Agenda Item # 18

SUB-003760-2026 & SUB-SW-003756-2026

Hackbarth Gardens Subdivision

APPLICATION NUMBER	18	DATE	June 18, 2026
APPLICANT	Hackbarth Gardens Subdivision		
REQUEST	Subdivision, Sidewalk Waiver

SITE PLAN

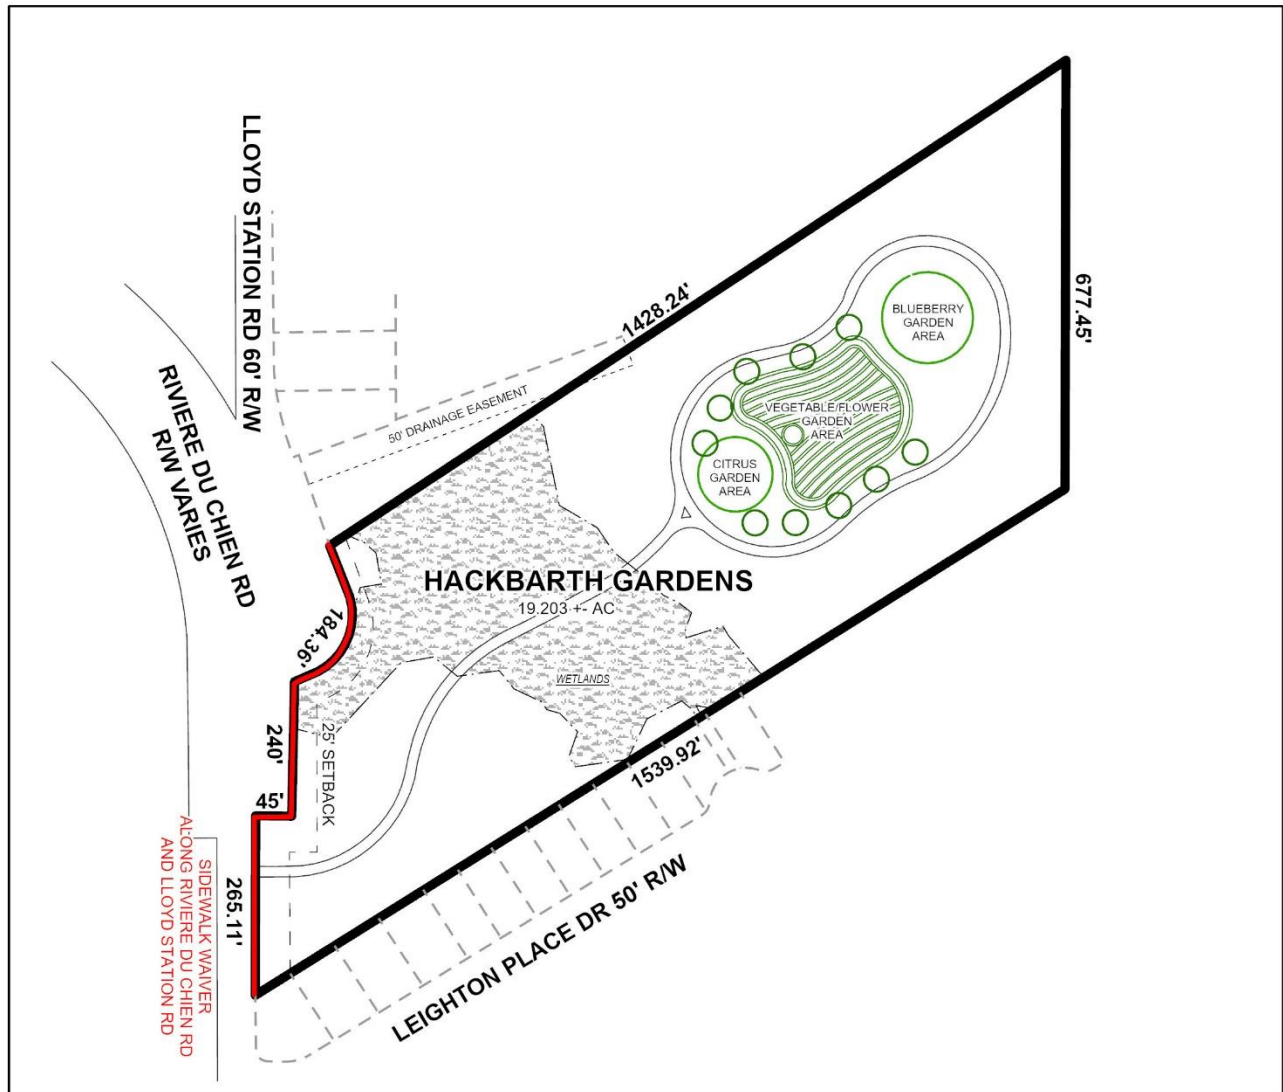
The preliminary plat clearly identifies the proposed lot lines; however, the new lot is not labeled "Lot 1" or a similar designation. If approved, the resulting lot should be labeled "Lot 1" on the Final Plat.

The site has frontage on Riviere Du Chein Road and Lloyd Station Road, both minor streets without curb and gutter. The preliminary plat indicates that Lloyd Station Road has an existing compliant 60-foot-wide right-of-way. Riviere Du Chein Road is depicted as having a varying right-of-way. As such, if approved, either dedication should be made to provide 30 feet from the centerline of Riviere Du Chein Road or the plat should depict that such right-of-way currently exists.

The preliminary plat illustrates the required 25-foot minimum front yard setback along the entire frontage. If approved, these setback lines should be retained on the Final Plat. The preliminary plat also includes a note about side yard setbacks that are incorrect, as they pre-date the UDC. If approved, the note referencing side and rear setbacks should be removed from the Final Plat.

The preliminary plat indicates the proposed lot size in both square feet and acres. If approved, this information should be retained on the Final Plat, adjusted for any dedication required.

The preliminary plat depicts a portion of a 50-foot drainage easement within the proposed Subdivision. If approved, a note should be placed on the Final Plat stating that no structure shall be constructed or placed within any easement without permission of the easement holder.

The applicant requests a waiver of the requirement to construct a sidewalk along the Riviere Du Chein Road. There are no existing sidewalks in the area along either Riviere Du Chein Road or Lloyd Station Road.

In support of the waiver request, the applicant states that this is a rural residential area, with no connecting sidewalks. Furthermore, the applicant states that a turning lane onto Lloyd Station Road along the frontage would create unsafe pedestrian walking conditions. No cross-sections of the topography were provided to illustrate that a sidewalk would be undesirable.

Engineering staff have indicated that sufficient space appears to exist either within the right-of-way or on the subject property to accommodate a sidewalk, which could be permitted through the right-of-way permit process.

1. Retention of the 60-foot-wide right-of-way along Lloyd Station Road on the Final Plat;
2. Either dedication to provide 30 feet to the centerline along Riviere Du Chein Road or illustration that such right-of-way currently exists;

3. Label the new lot as "Lot 1";
4. Retention of the lot size in square feet and acres, or provision of a table on the Final Plat with the same information, adjusted for dedication;

5. Revision of the Final Plat to remove the side and rear yard setback notes;
6. Retention of the 25-foot minimum front yard setback line along the entire frontage;

7. Placement of a note on the Final Plat stating that no structure shall be constructed or placed in any easement without permission from the easement holder;
